3699 MARINE WAY (COMPLETE APPLICATION)
DE418252 - ZONE CD-1

DEVELOPMENT PERMIT STAFF COMMITTEE MEMBERS

- **Proposal:** To develop this site with two, six-storey multiple dwelling residential buildings containing a total of 273 dwelling units and one, two-storey amenity building over two levels of common underground parking.

DEVELOPMENT PERMIT STAFF COMMITTEE RECOMMENDATION: APPROVE

Figure 4: Illustrative Form and Development Parcel 43

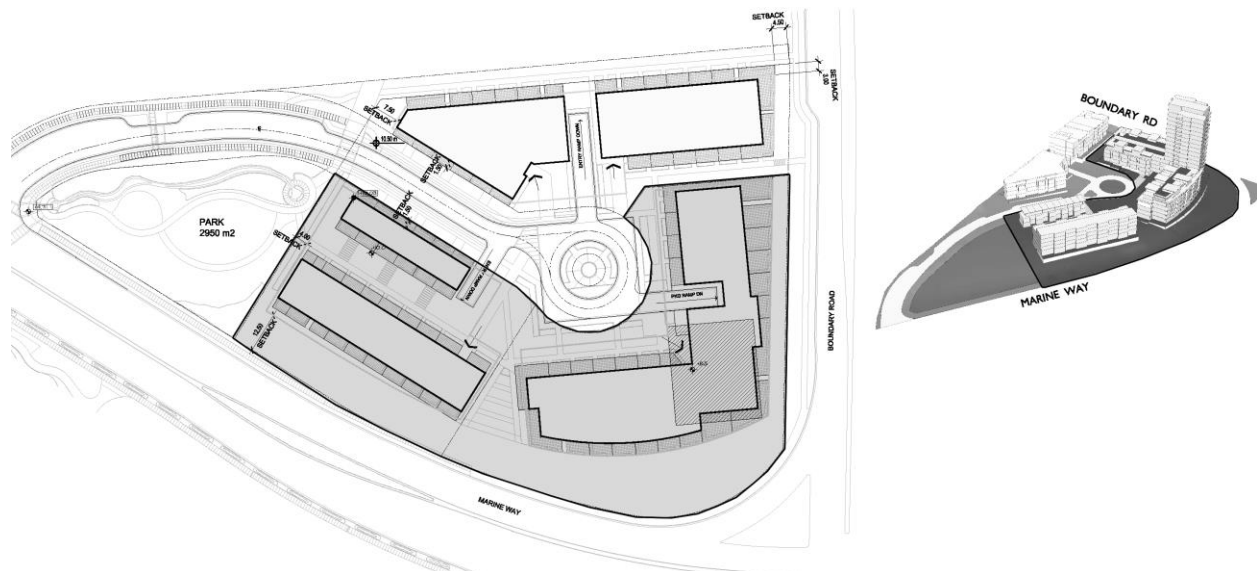
The Guidelines contain an illustrative form of development for each parcel that demonstrates form and density. The guidelines state that the 3D illustrative built form is intended as a guide and modification will result from further design development during the development permit process. The guideline allocation of floor space for Parcel 43 is 342,680.3 sq. ft. (31,835 m²) of residential, of which 93,431 sq. ft. (8,680 m²) are reserved for affordable housing dwelling units. This allows 249,238 sq. ft. (23,155 m²) for the market residential proposed in this current development application. The guidelines note that floor space can be reallocated between parcels provided the intent of the guidelines is met.

- On the southern edge of Parcel 43, a denser row of trees and landscaping provide a green edge that enhances the living environment of this residential parcel.
- Centering the composition of the parcel's buildings and the landscaping is a well-defined coherent open space buffered from Marine Way; the open space provides a quieter green outlook for the units around it; free of underground structure, it can accommodate trees of a generous scale.
- Access to the parcel extends from the intersection of Marine Way and Crescent, allowing easy pedestrian and vehicular crossing to and from the Town Square precinct.
- Crossover units in the westerly building along Marine Way provide views and quiet side for each dwelling.
